FRIENDS of Banks Peninsula Inc.
Akaroa's Community Environment Society since 1990

**Evaluating
BECA Ltd: Akaroa Wastewater Scheme
Design Flow Basis Update Report
Report to Environment Canterbury**

15 April 2024

Figure 2 Modelled versus Measured flow graph from Update Report

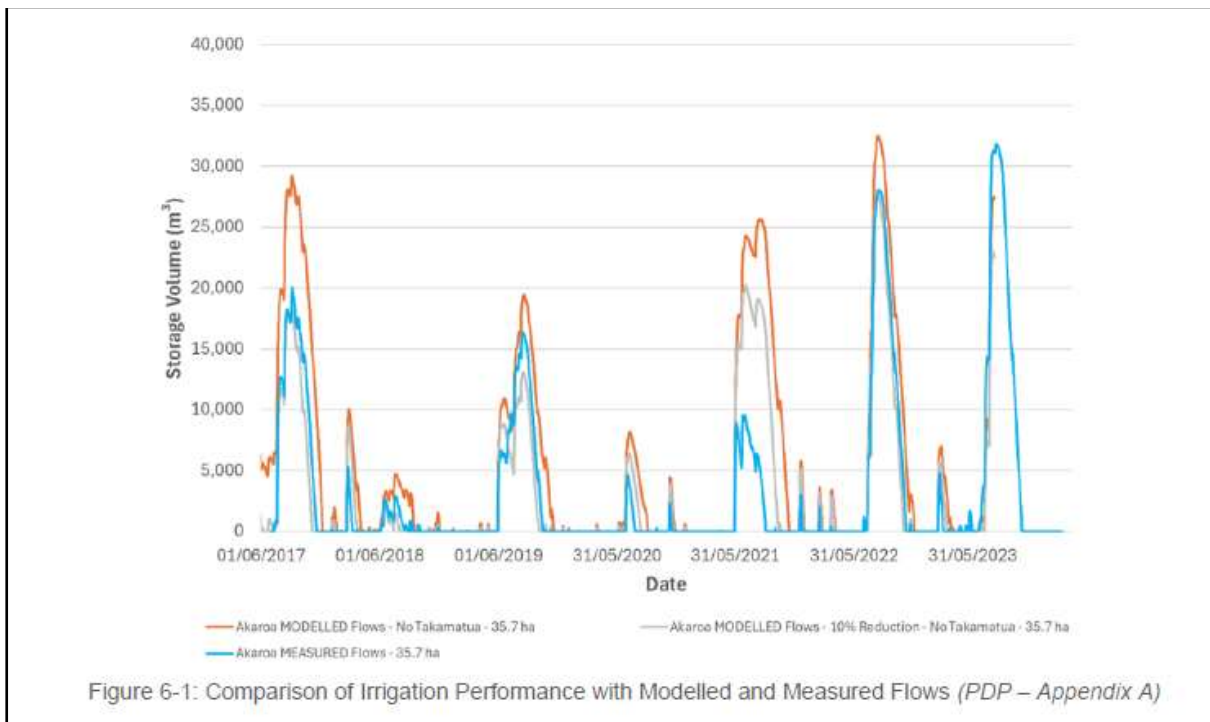
The Update Report recommends that an appropriate margin above that predicted by the revised modelling should now be considered when sizing the infrastructure for the wastewater system²³, to cover weather and usage anomalies that the modelling does not account for, but it does not suggest how large this margin should be.

The Consent Application originally provided an 8,000m³ (66%) capacity margin for the storage, because although 12,000m³ was considered sufficient with no overflows anticipated, the consent applied for up to 20,000m³. That 20,000m³ capacity has been shown to be insufficient, so there is no margin on the storage.

Friends of Banks Peninsula recommends that in terms of the storage capacity, at least 40,000m³ is required. The graph below from the Update Report compares storage requirement using the modelled flows (in orange) with the storage requirement based on the measured flows (in blue). This shows that in 2023, approximately 32,000m³ of storage would have been required. In addition as noted above, the storage modelling in the Update Report does not take into account ***the fundamental principle that no irrigation will occur where land conditions are likely to result in surface ponding***. It appears that as yet no data has been collected on how long the land remains saturated after prolonged winter rain. On the basis of the photographs taken 7 days after the July 2023 event had ceased, at least another 4,000m³ of storage would have been needed. If a further margin matching the original 8,000m³ is added on top of this, it suggests that storage of close to 44,000m³ would be needed to cope with the actual wastewater flows measured over the past 6 years. We note this calculation still uses the higher irrigation rates which Beca seems to imply may affect land stability.

Figure 3 Difference from reducing I&I by 20% and to 20%

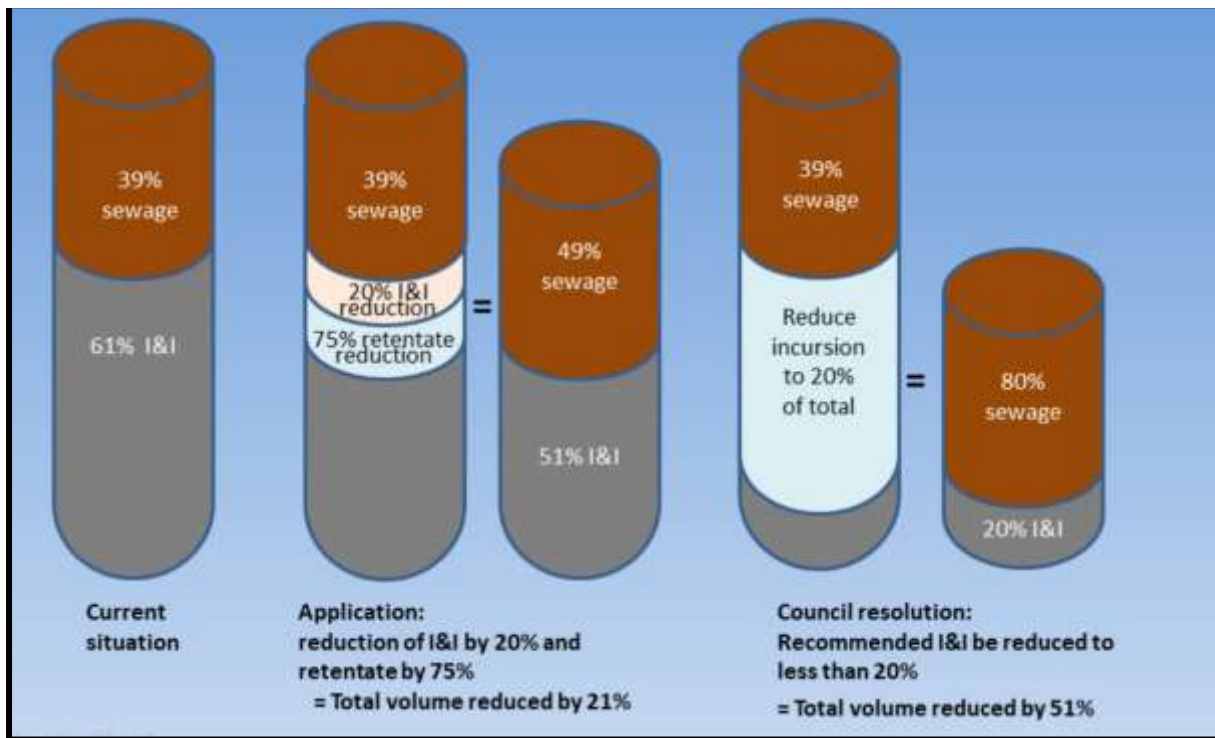
This is a substantial difference as shown in the diagram below.

Had the Council recommendation been followed, the total volume of the wastewater would have been reduced by 51%. With the reductions set out in the consent application the total volume is only being reduced by 21%.
